Access Compliance Report

Public Rights-of-Way

Intersection ID: 49893	Main Street: ROCKY_FORD_CLUB_RD	Cross Street: RIDGEVIEW_COMMONS_DR	Location: W
ADA ID: 1A3B331787BA	Ramp Type: Perp	Initial Pass/Fail: Fail	Overall Compliance: No
		Severity Score: 22.5

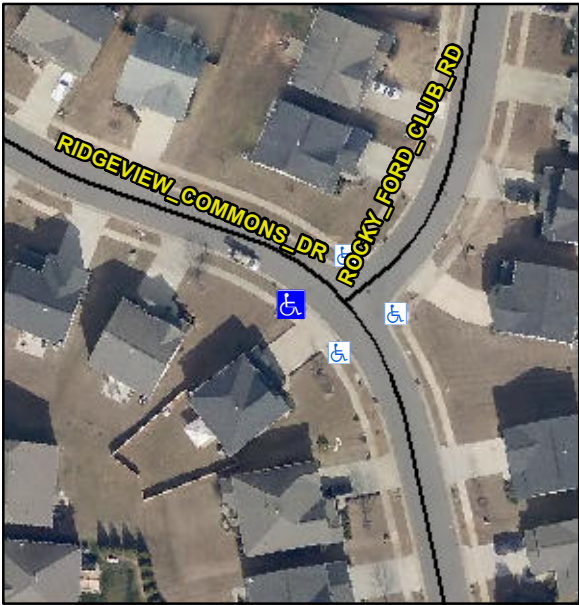
Codes/Mitigation Info/Possible Solution			Field Measurements/Component Compliance					
 <p>Street 1 Name RIDGEVIEW COMMONS DR</p> <p>Stop Condition-Street 2 None</p> <p>Street 2 Name N/A</p> <p>Stop Condition-Street 1 N/A</p>	Possible Solutions:		Compliance	Description	Data	Compliance	Description	Data
	Remove & Replace Entire Ramp.		N/A	Ramp Length (in)	70.0	No	Ramp Slope (%)	9.3
			No	Ramp Width (in)	47.0	No	Ramp XSlope (%)	3.2
			N/A	Flare Type LT	N/A	N/A	Flare Type RT	N/A
			N/A	Flare Slope LT (%)	N/A	N/A	Flare Slope RT (%)	N/A
			N/A	Flare Traversable LT?	N/A	N/A	Flare Traversable RT?	N/A
			N/A	Landing Length (in)	N/A	N/A	DWS Provided?	N/A
			N/A	Landing Width (in)	N/A	N/A	DWS Contrast?	N/A
			N/A	Landing Slope (%)	N/A	N/A	DWS Length (in)	N/A
			N/A	Landing X Slope (%)	N/A	N/A	DWS Full Width?	N/A
Surveyor Notes:		N/A	N/A	Landing Curb? (Y/N)	N/A	N/A	DWS Offset (in)	N/A
			N/A	Shared Landing?	N/A

PROW/ADA:			N/A	Gutter Ponding?	N/A	N/A	Gutter Slope (%)	N/A
R304.5.1, R304.2.2, R304.5.3			N/A	Gutter Lip Ht (in)	N/A	N/A	Gutter X Slope (%)	N/A
			N/A	Painted X Walk1?	No	N/A	Painted X Walk2?	N/A
				X Walk 1 Direction	To NE		X Walk 2 Direction	N/A
			N/A	X Walk 1 Width (in)	N/A	N/A	X Walk 2 Width (in)	N/A
				X Walk 1 Slope (%)	1.6		X Walk 2 Slope (%)	N/A
				X Walk 1 X Slope (%)	2.0		X Walk 2 X Slope (%)	N/A
			N/A	Ramp inside XWalk1?	N/A	N/A	Ramp inside XWalk2?	N/A
				Road Slope (%)	N/A	N/A	Clear Space?	N/A
				Road X Slope (%)	N/A	N/A	Clear Space to XWalk (in)	N/A
			N/A	Any Obstructions?	N/A	N/A	Storm Grate/Utility Hazard?	N/A
				Obstruction Type			Storm Grate/Utility Type	
					N/A			N/A
						Yes	Surface Condition? (G/P)	Good
Total Cost:		\$ 1850.00
